**RESPONSES TO DECEMBER 16, 2011 COMMENTS FROM MOE REGARDING  
CRA'S HYDROGEOLOGICAL ASSESSMENT, DATED DECEMBER 8, 2011  
WOOLWICH BIO-EN INC. FACILITY  
ELMIRA, ONTARIO**

**HYDROGEOLOGICAL ASSESSMENT COMMENTS**

### **GEOTECHNICAL INVESTIGATION (DECEMBER 2011) COMMENTS:**

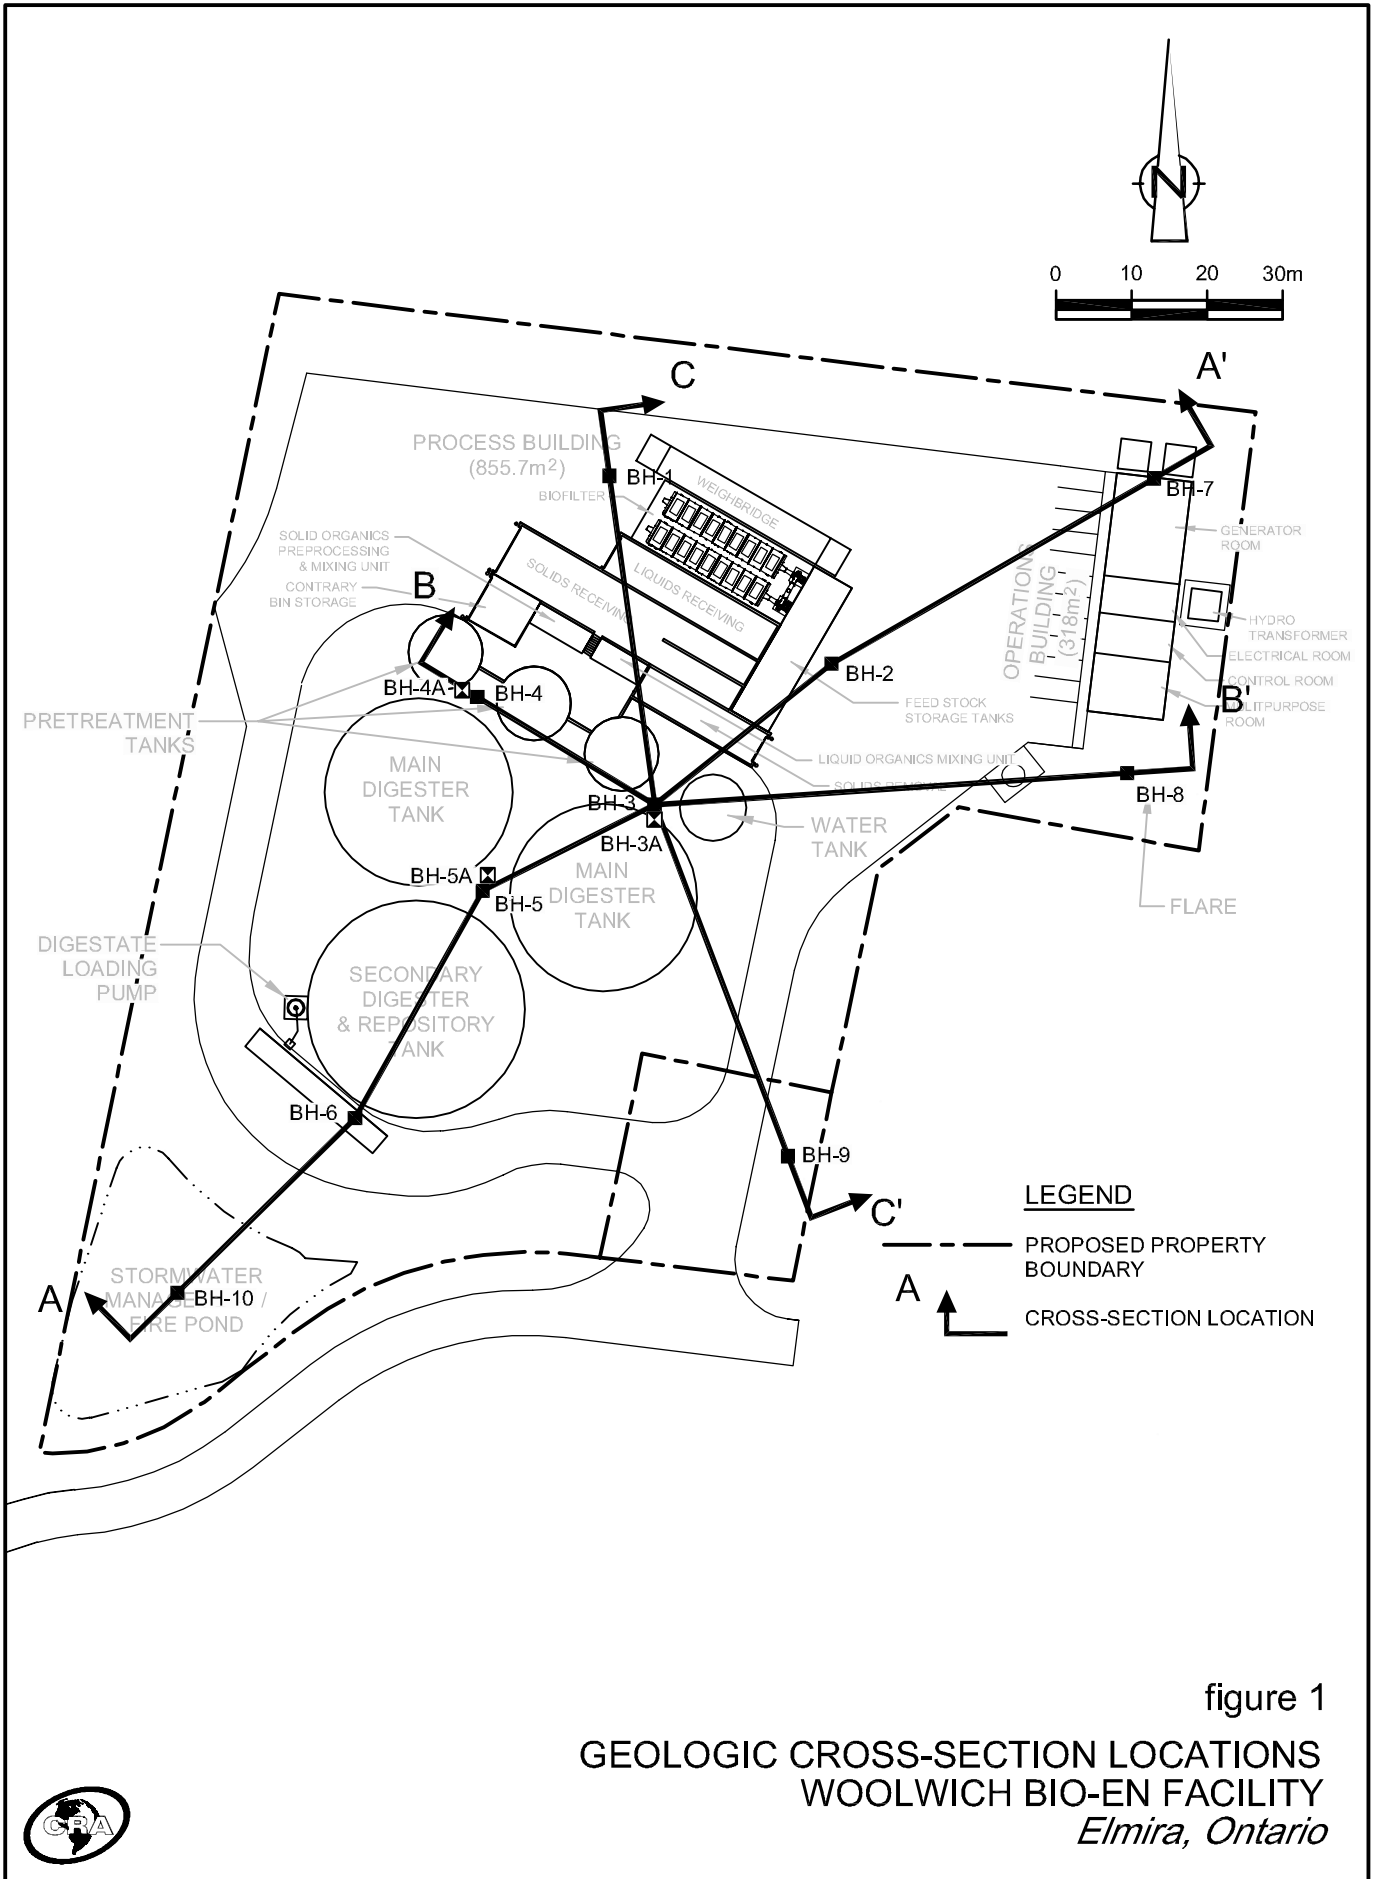
*CRA advanced boreholes in the vicinity of the original boreholes advanced by CVD and used the same nomenclature (i.e., BH-3, BH-4, and BH-5); however, the locations of the CRA boreholes were not provided on a figure. The location of the boreholes advanced by CRA should be provided on a figure.*

- i. *Location of the new boreholes has not been identified in any of the diagrams provided with either D&O report or the Geotechnical Investigation report. Please provide a diagram that shows the location of these boreholes and also provide their borehole logs.*

Figures and references are revised to show the location nomenclature (e.g., "BH-5/BH-5A") to indicate both CVD and CRA boreholes were completed at this location. These figures are provided in Attachment 1 and are included in the revised Geotechnical Report.

Figures and references are revised to show the location nomenclature (e.g., "BH-5/BH-5A") to indicate both CVD and CRA boreholes were completed at this location. These figures are provided in Attachment 1 and are included in the revised Geotechnical Report.

figure 2  
 GEOLOGIC CROSS-SECTION A-A'  
 WOOLWHICH BIO-EN FACILITY  
 Elmira, Ontario

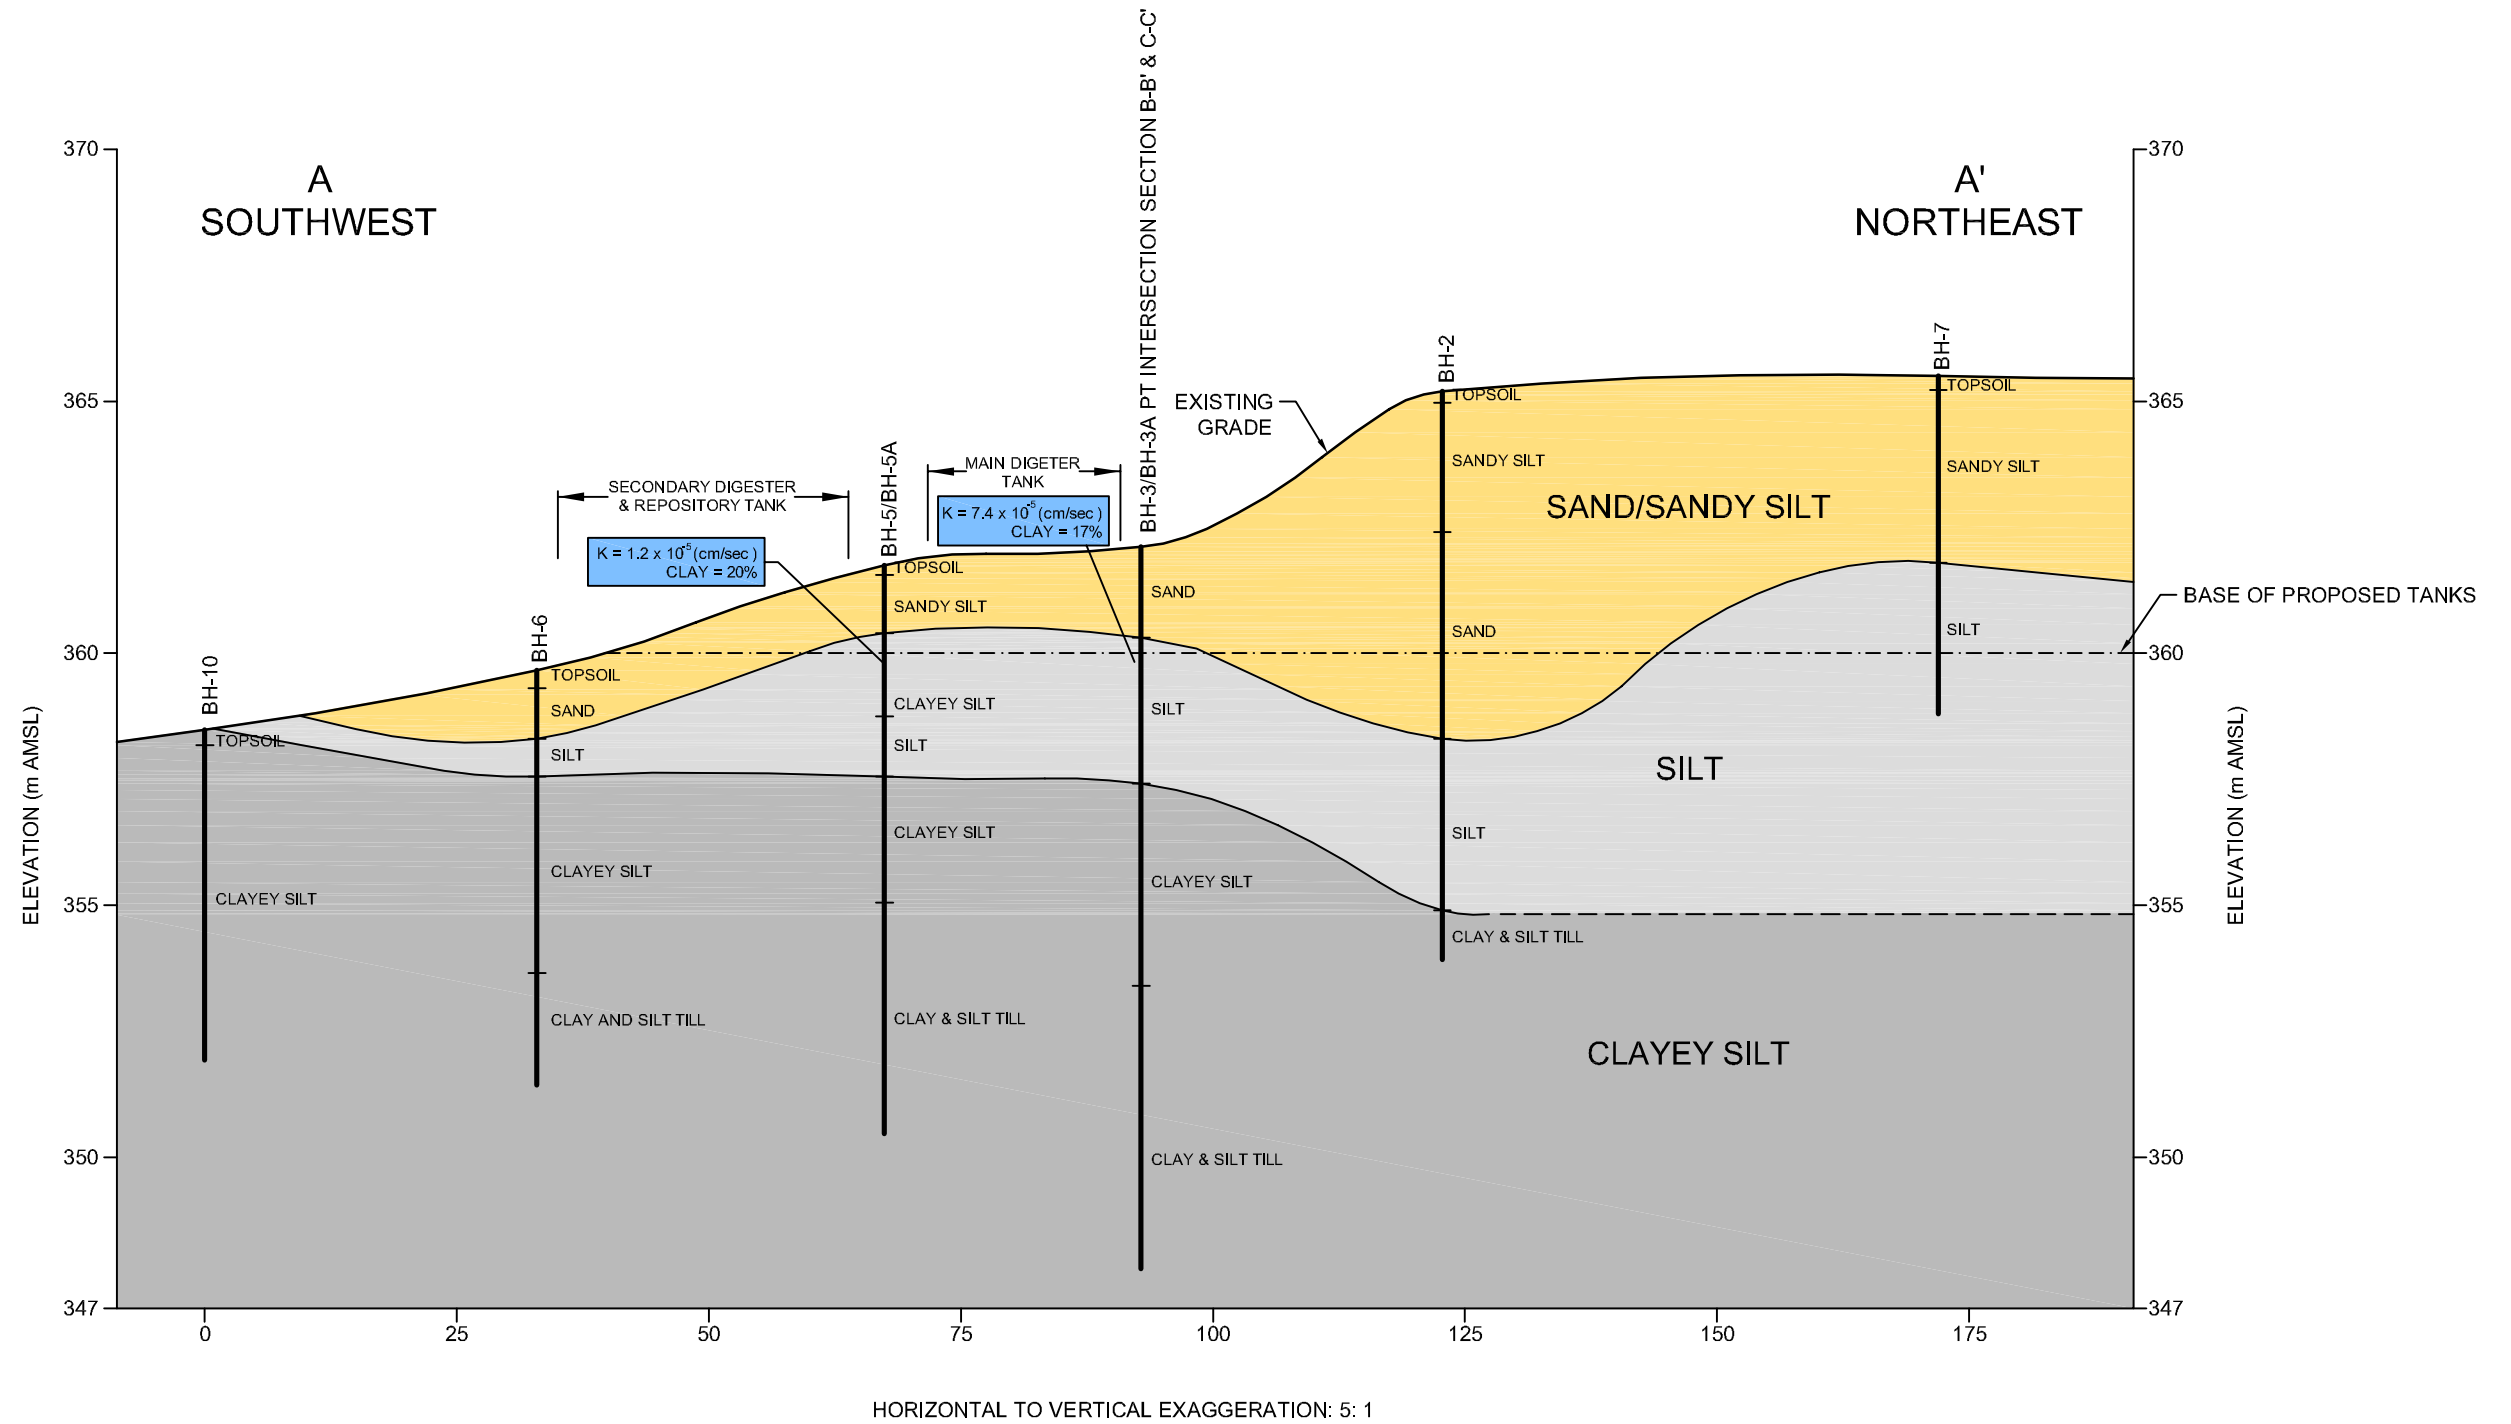
*Based on the cross-sections provided and the proposed base elevation of 360 m AMSL for the Main Digester Tanks and Secondary Digester Tanks, it appears that the sandy silt and/or sand to gravelly sand unit will be removed during Site re-grading near some of the borehole locations, including BH-3, BH-4, and BH-5. However, the borehole log for BH-6 suggests that at an elevation of 360 m AMSL, the Secondary Digester & Repository Tank will be underlain by a thin sand, some silt layer. As the SAT and Upper Aquifer thicknesses are extremely variable in the vicinity of the Site, it is possible that portions of the tank may not be underlain by at least 1.0 m of soil with a clay content of at least 10%.*

The sand layer identified at the ground surface of the Site is not part of the Upper Aquifer. The Site-specific geologic cross-sections presented on Figures 8a, 8b, and 8c, show that the "Sand/Sandy Silt" layer is present between elevations of approximately 365 and 357 m AMSL above a thick layer of fine-grained material ("Silt" and "Clayey Silt") and ranges in thickness, where present, between 0 m (BH-10) and 6 m (BH-1/BH-2) at the geotechnical boreholes completed in 2011 during geotechnical and hydrogeological investigation activities. Furthermore the "Sand/Sandy Silt" layer is for the most part dry.

on Figures 8a, 8b, and 8c, show that the "Sand/Sandy Silt" layer is present between elevations of approximately 365 and 357 m AMSL above a thick layer of fine-grained material ("Silt" and "Clayey Silt") and ranges in thickness, where present, between 0 m (BH-10) and 6 m (BH-1/BH-2) at the geotechnical boreholes completed in 2011 during geotechnical and hydrogeological investigation activities. Furthermore the "Sand/Sandy Silt" layer is for the most part dry.
